TBO für ROTAX Motor Type 912 UL Serie

Increase of TBO from 600h or 10 years to 1200h or 15 years of operation.

All engines of Series Type 912 UL starting with engine no. 4,152.667.

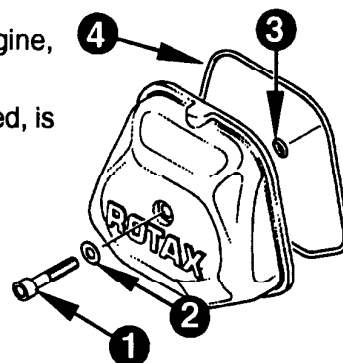
Disconnect minus terminal of the battery. Remove Allen screw M6x30 ① and washer ② from valve cover and take off cover along with o-rings ③ and ④.

Set cylinder 1 to ignition T.D.C. Fit dial gauge ⑤ to indicate any movement of valve spring retainer ⑥. Fit test lever ⑦ part no. 877 690 in hollow rocker arm shaft ⑧ and determine the spring tension on both valves by utilizing a spring balance. Read value on the balance, part no. 877 700, between 0,2 + 0,3 mm (.008 + .012 in.) indication on dial gauge.

The value shown on the spring balance must not be below 35 N (8 lbf). Valve springs with lower tension must be renewed. Clean sealing face, place both o-rings on valve cover and attach cover with Allen screw M6 x 30 and washer. Tightening torque 10 Nm (90 in lb).
